BAKERSFIELD
 CITY SCHOOL
 DISTRICT

MODERNIZATION AT
 CURRAN MIDDLE
 SCHOOL
 FOR:

MARK	DATE	DESCRIPTION
SD		
CD	08/29/07	ADDENDUM 1
AD	09/11/07	ADDENDUM 2
AD	11/01/07	ADDENDUM 3

INTERIOR ELEVATIONS BUILDINGS E

SHEET IDENTIFICATION NUMBER
A-237
 SHEET 28 OF 46

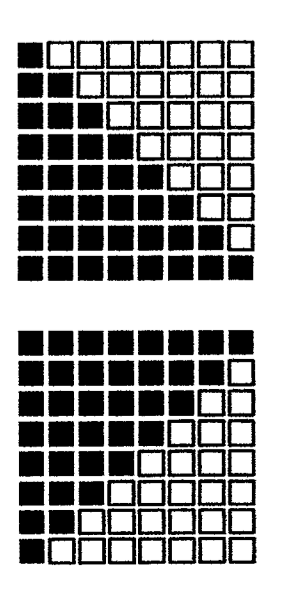
Item No. 15: Refer to Sheet A-237. Elevations 7'-8" & 9" Kerolan #27 hinges refer to metal #12 at doors and #05 at vents. Reverse Kerolan #02 to head. Remove and replace existing counter top with custom countertop with 6 splash (unless noted otherwise) call to wall typical. Delete Kerolan 05 replace all doors, drawer fronts, & face plates. Finish per specifications.
